1435 - P095

Bedroom//Existing///Plan_1:20

Rev	Date	Notes
A	23.06.15	Radiator added and joinery removed .

Bedroom//Existing//Plan_1:20

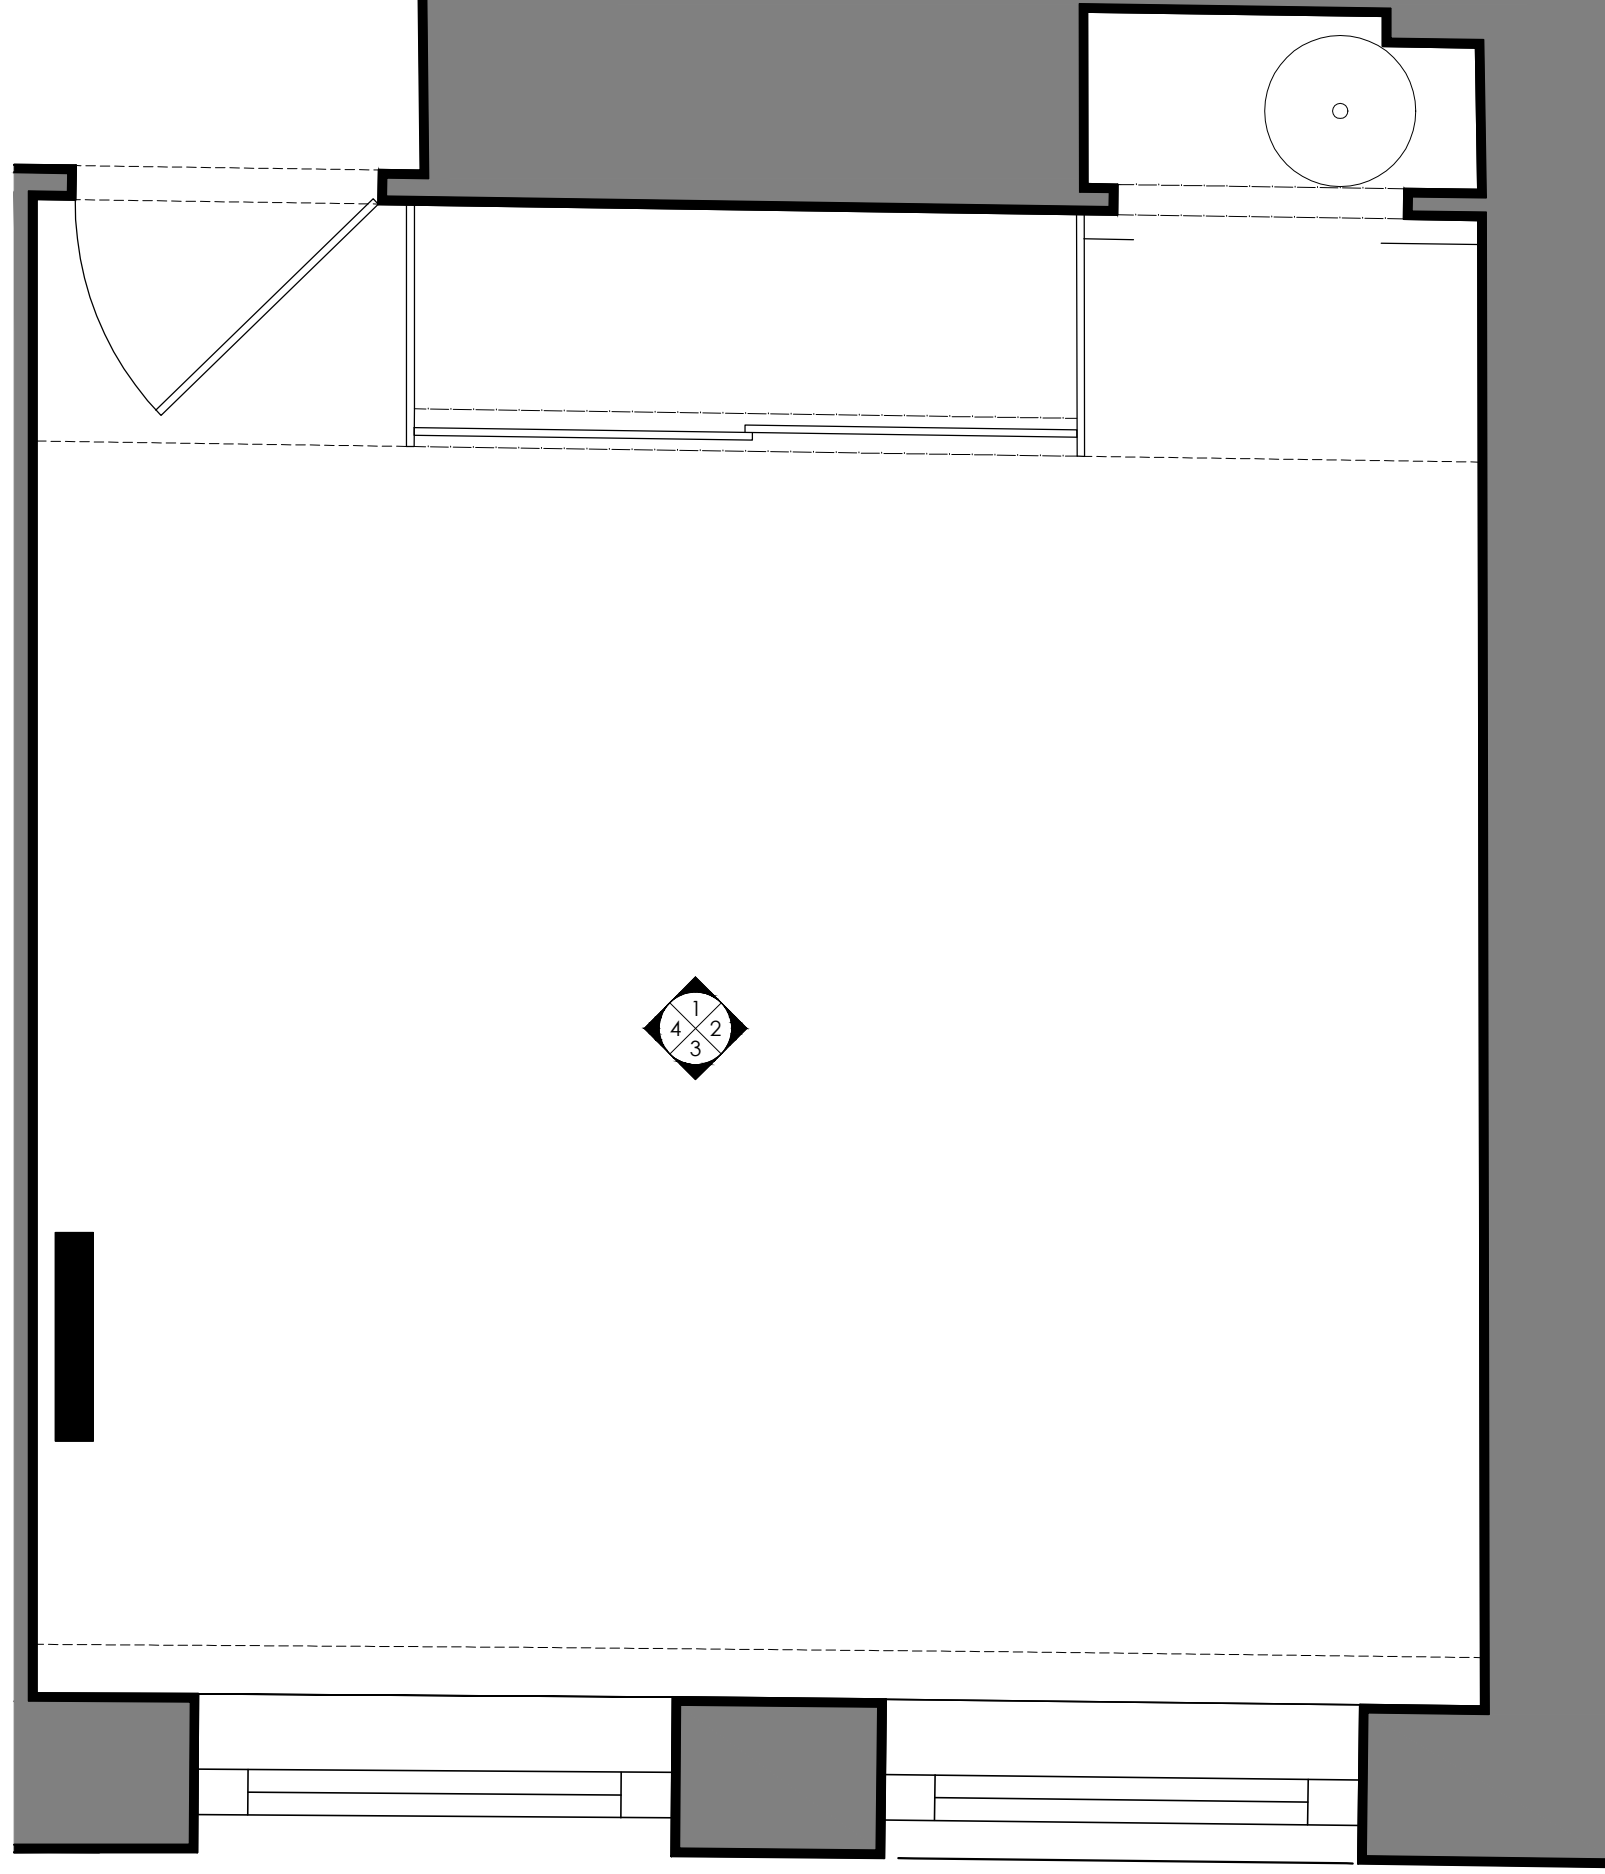
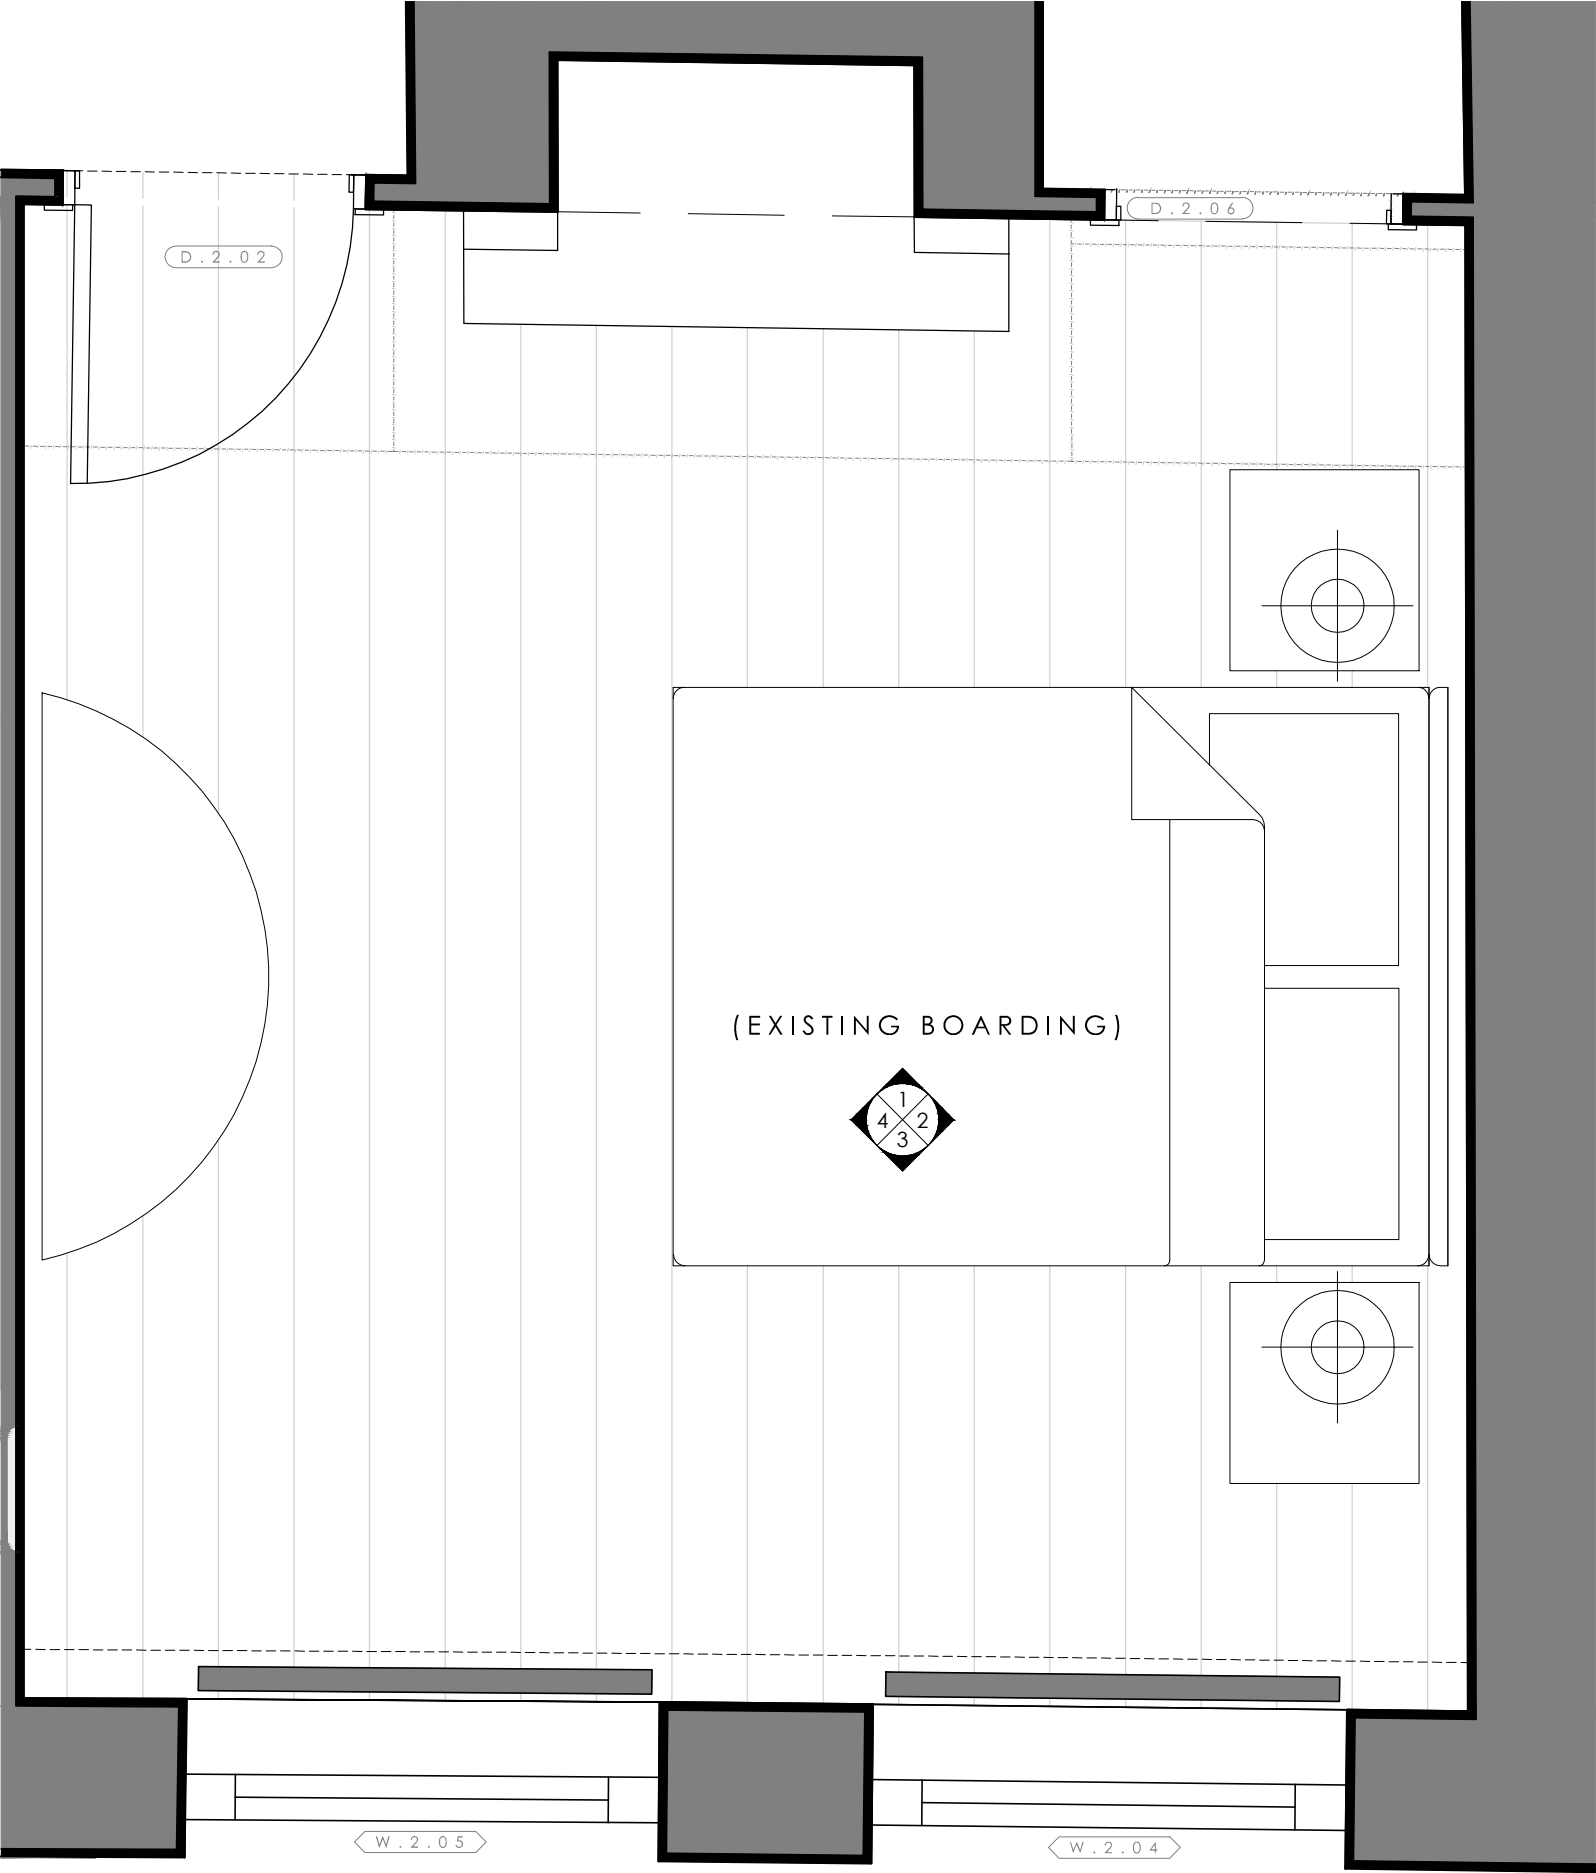
Rev	Date	Notes
A	23.06.15	Radiators added.

Bedroom//Existing//Elevation 2_1:20

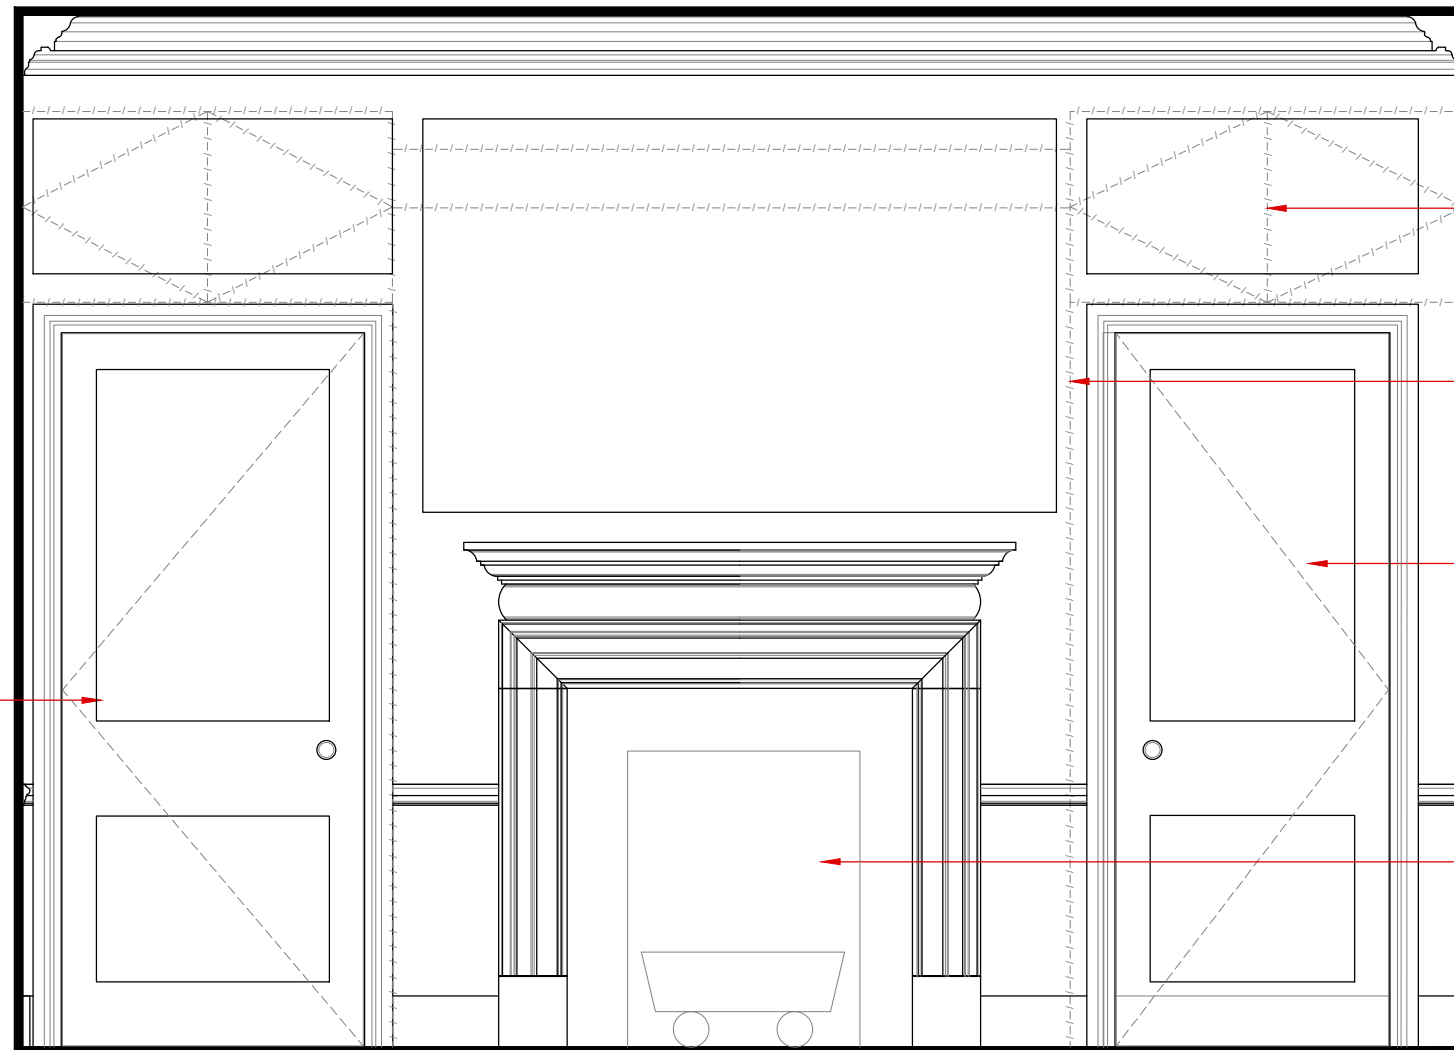
Existing door replaced
to match D.1.06.
Architrave to be 75mm.

Proposed simple
panelling to match
elevation 3.

Existing fixed cupboards
removed. Wall
reinstated to house
doorway.

Proposed doorway. Door
to match D.1.06.

Existing fireplace
opening reduced. New
surround and hearth
proposed.

Bedroom//Existing//Elevation 3_1:20

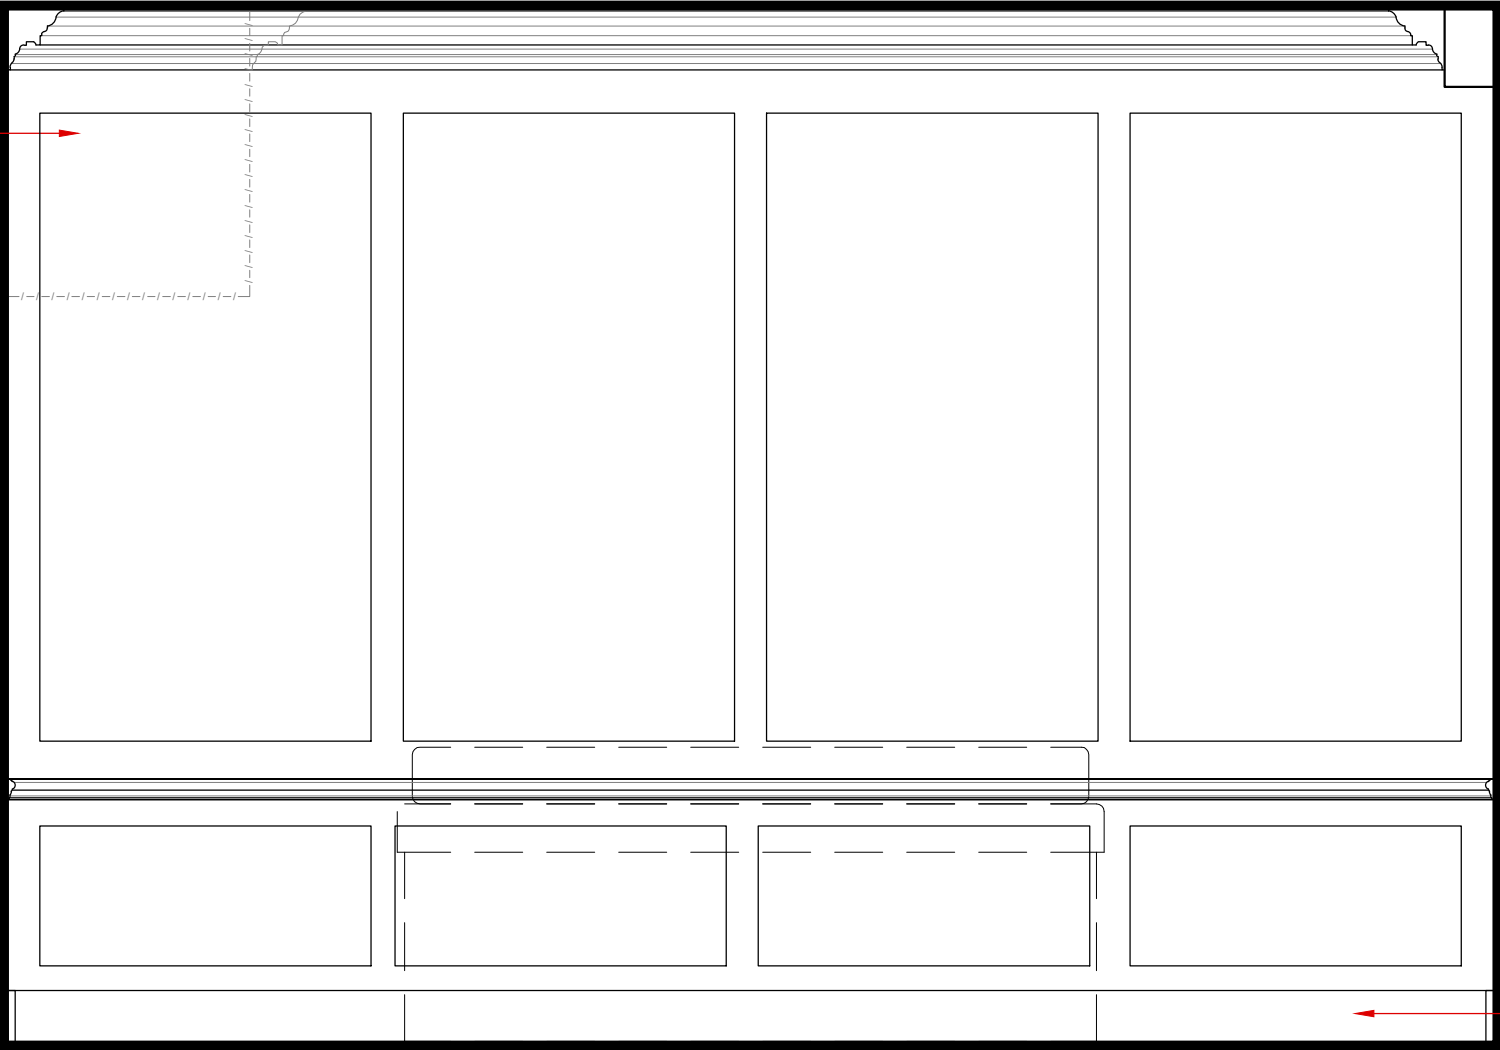
Existing fixed cupboards removed. Existing cornice reinstated to wall.

Existing skirting to remain as existing.

Bedroom//Existing//Elevation 4_1:20

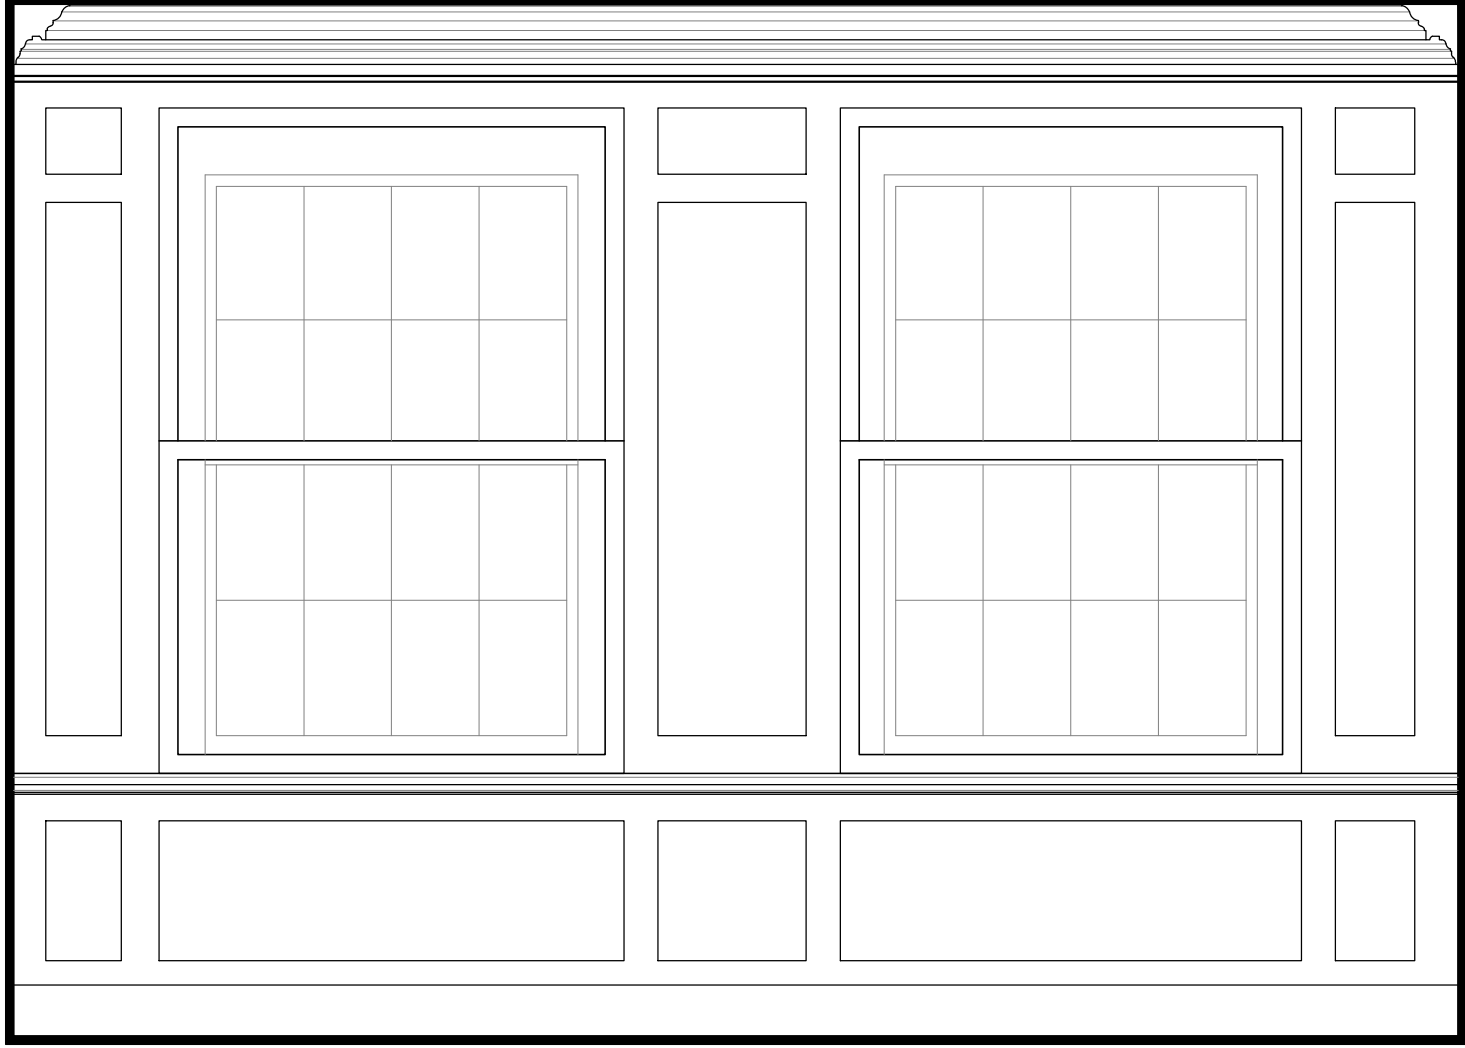
Cornice to remain as existing.

Existing secondary glazing removed and replaced with new.

Rev	Date	Notes
A	23.06.15	Radiators added.
